Service Note		
Products	Description:	Service note no.
Nova System	Tuner is flat	SNo-T217

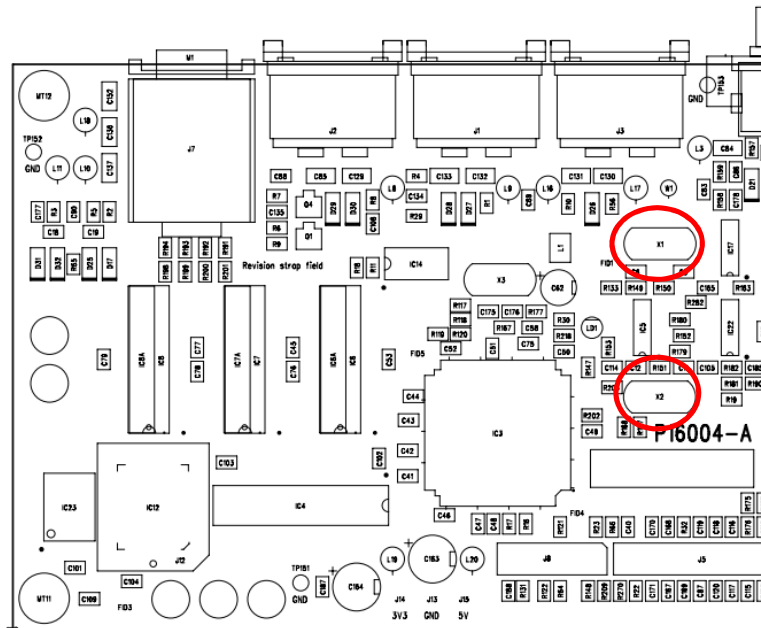
We have experienced that some Nova Systems are tuning flat. A 440 Hz test tone registers as a B flat on the tuner instead of an A.

The reason is that the two crystals X1 and X2 on the mainboard by accident have been mixed up in the manufacturing process.

To fix the problem just carefully unsolder the two crystals on the mainboard, swap these and resolder them again. (Marked below with red circles)
